SEWAGE DISPOSAL SYSTEM

DEPARTMENT OF HEALTH AND MENTAL HYGIENE

SUBDIVISION Hallmark-Section 2 LOT 43 ROAD 7391 Hopkins Way

REPAIR - PURPOSE - TO ADJUST EXISTING SEWAGE EASEMENT IN SUPPORT OF PROPOSED POOL.

PROPOSED SECOND FLOOR PLAN 3

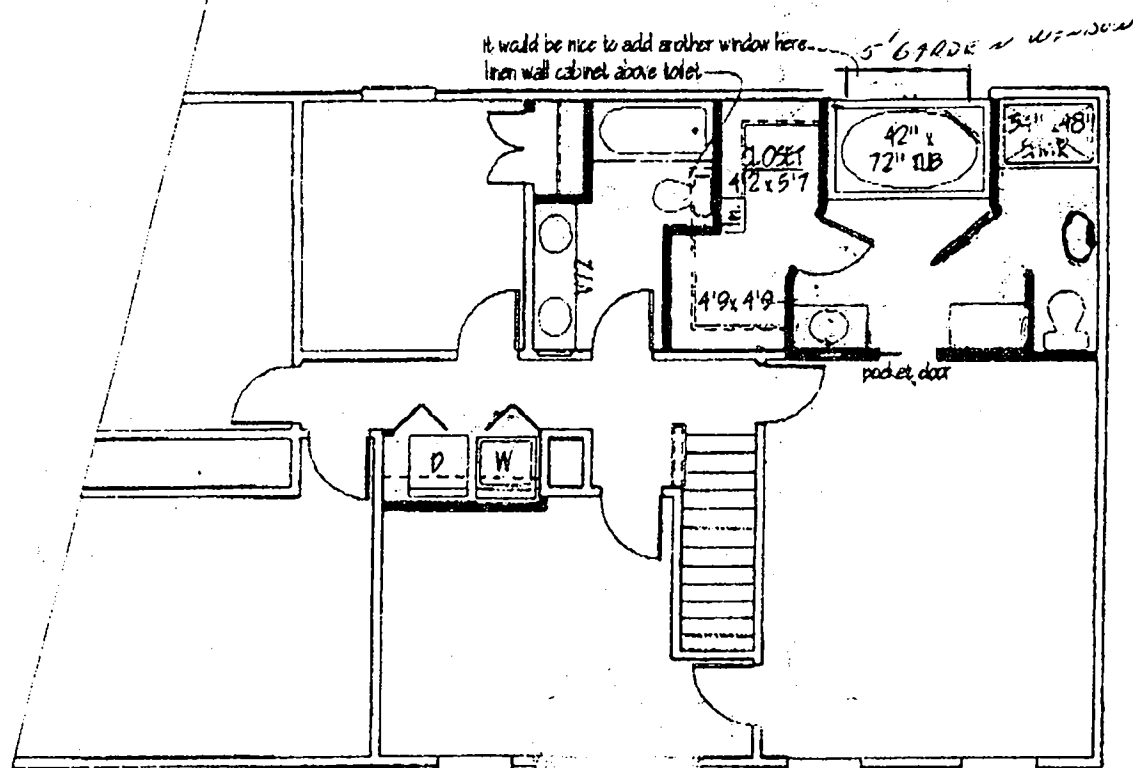
2/12/03
 changed
 to bathroom -
 no effect on
 brm, septic
 (KN)
